To:	All plan holders	From:	Tracy Bruun, Division
Pages:	34	Phone:	515-344-6279
Re:	Flo971628B Nutrient Reduction Wetland (Bid 26-07)	Date:	August 21, 2026

Subject: **Addendum No. 1** to Bid Documents
FLO971628B Nutrient Reduction Wetland Project – Bid No. 26-7
Floyd County, Iowa

NUTRIENT REDUCTION WQI WETLAND

**IDALS
FLO971628B
NUTRIENT
REDUCTION WQI
WETLAND**

C2-10

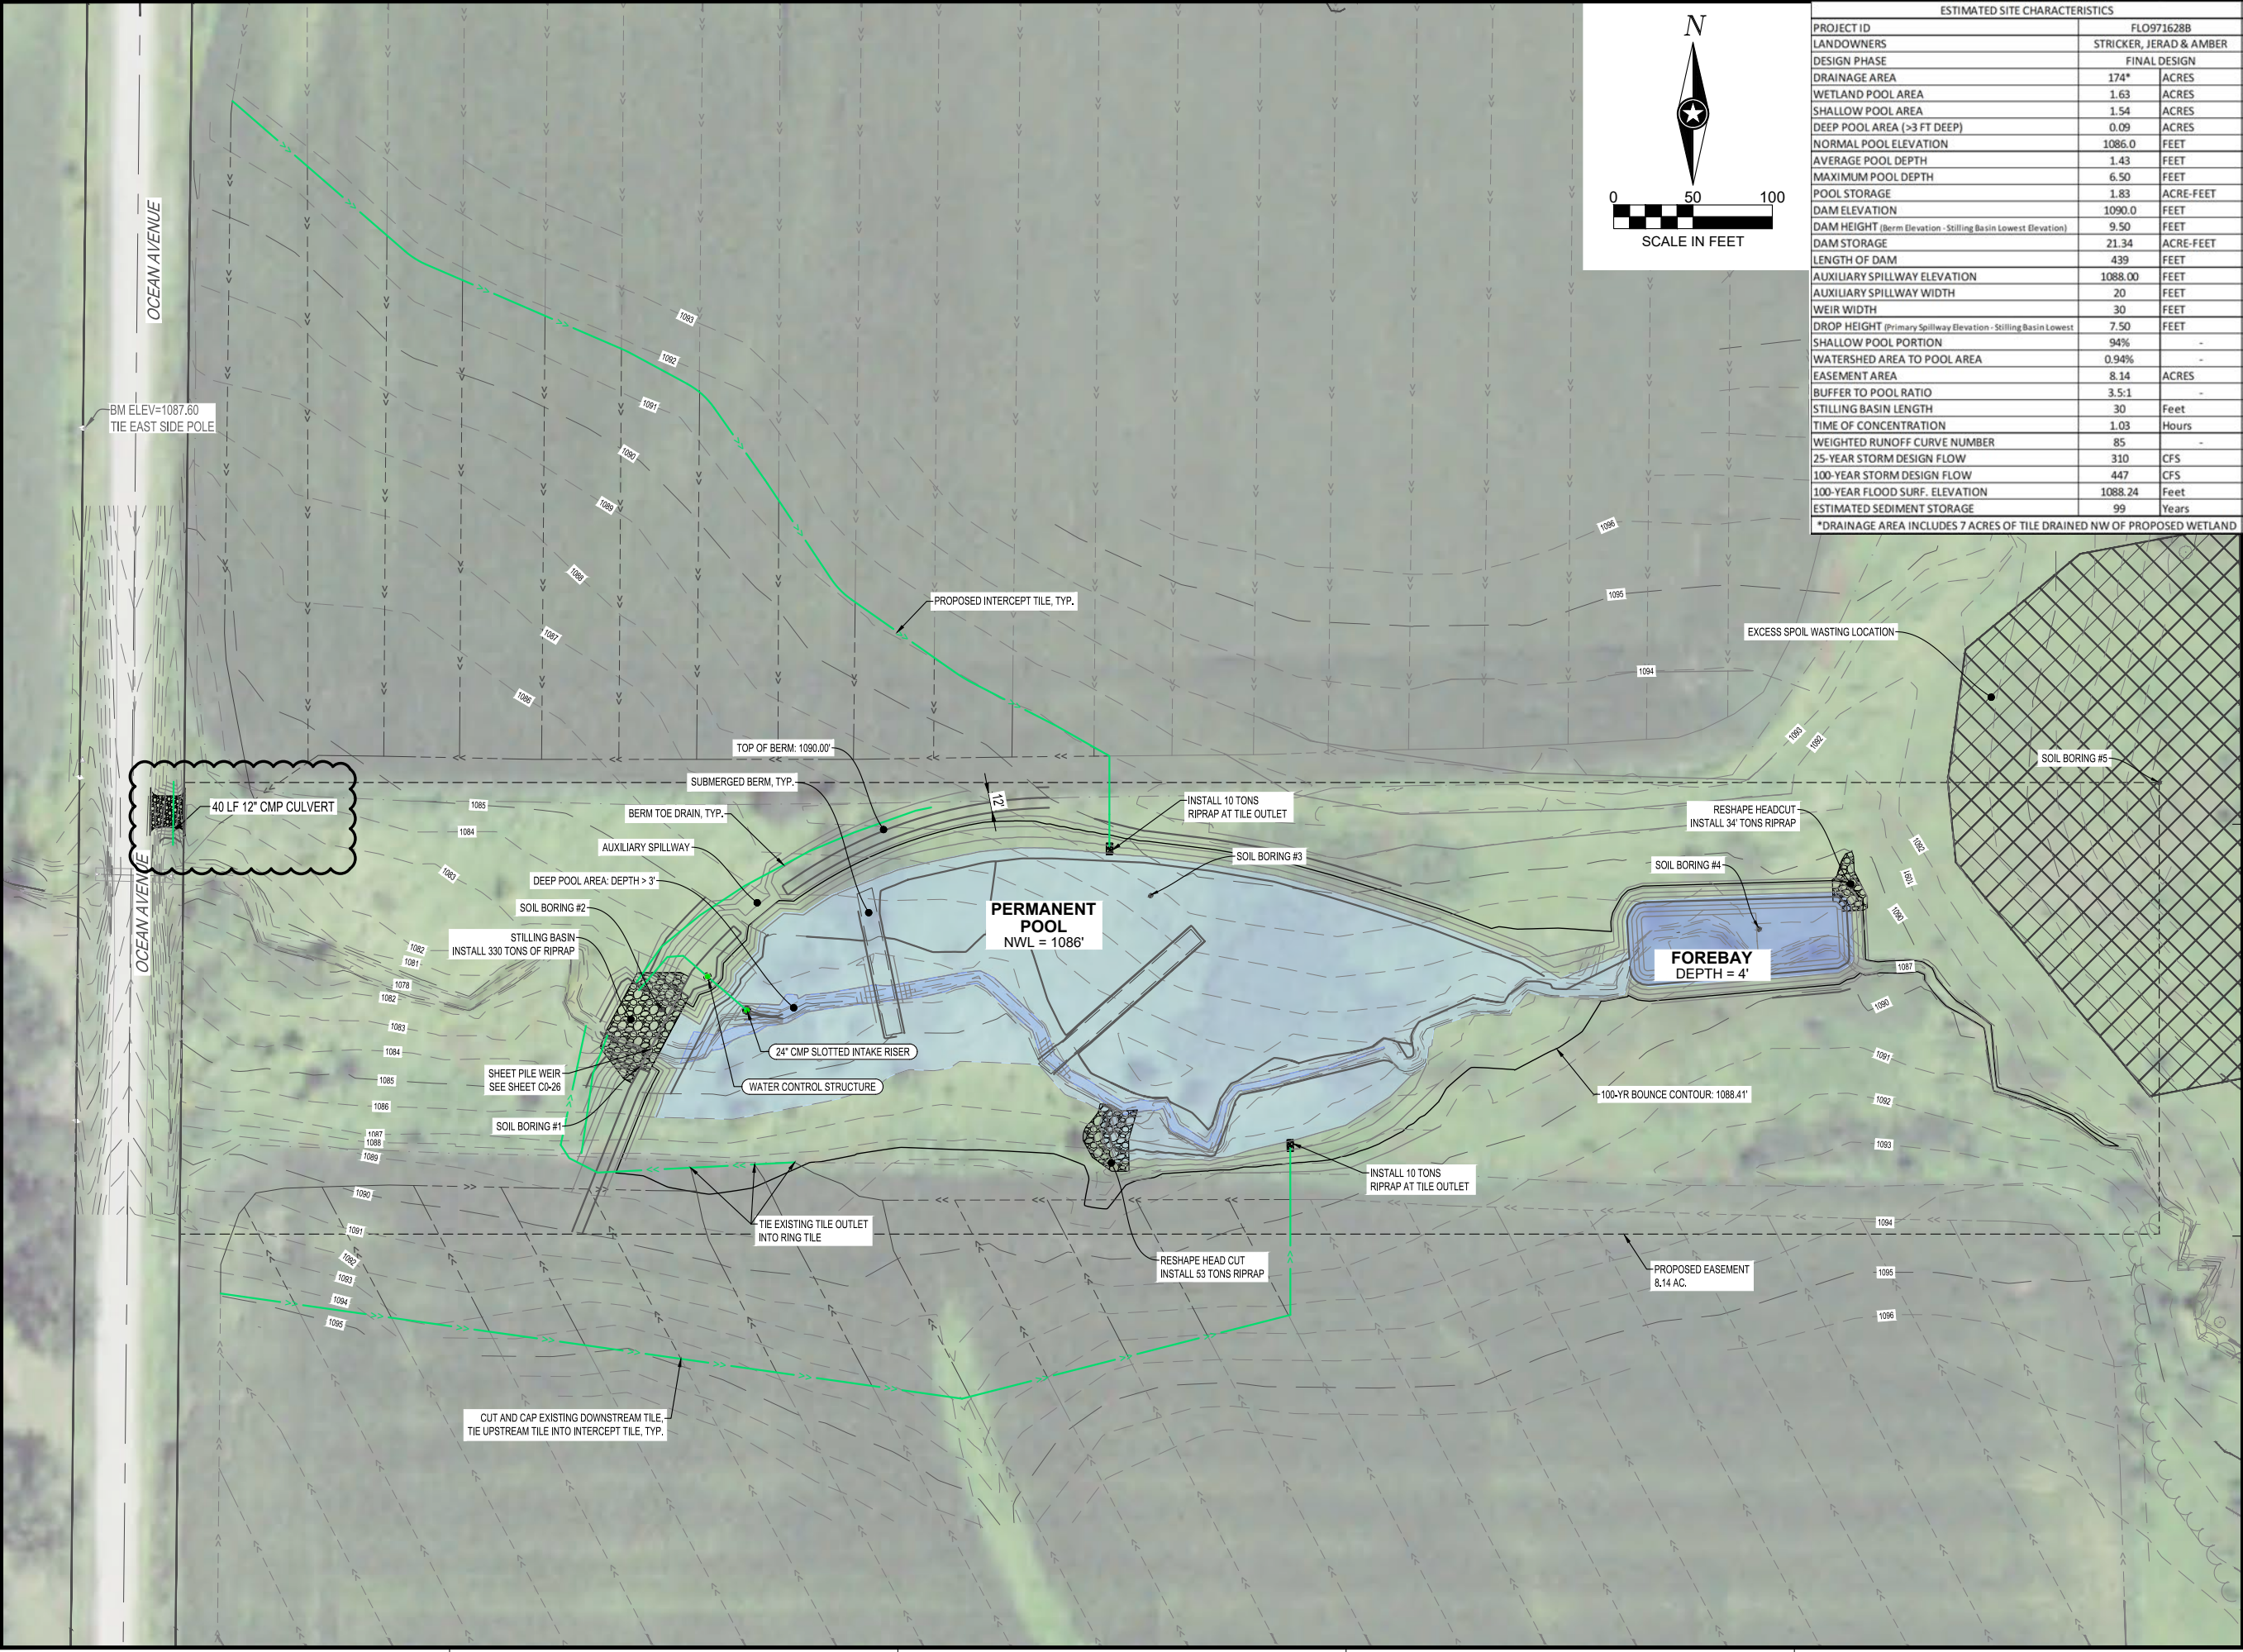
- The location of the proposed construction access has been modified, the location of the antiseep collar has changed and the sheetpile detail has been updated to provide more clarity. Attached are the revised set of Plans.

- b. Jerad asked to move driveway from S to N of waterway for access to WCS
- 5. CONCLUSION: There were no questions at the conclusion of the meeting
- 6. SITE VISIT: IDALS + ISG + 2/3 Contractors + Jerad were there

- DRIVEWAY: Move driveway to N of waterway (this was Jerad's request--his reasoning was for better access to WCS and stoplog storage)
 - This is less ideal from construction standpoint, regarding staging and access (probably have to put in temp water crossing)
 - There is at least one existing tile outlet to be mindful of here
- ANTI SEEP COLLAR: See sheet C3-34, we currently have anti-seep collar shown on upstream side of WCS--needs to be changed to downstream
- SHEET PILE DETAIL: See sheet C0-27, update shading to allow better legibility of elevations
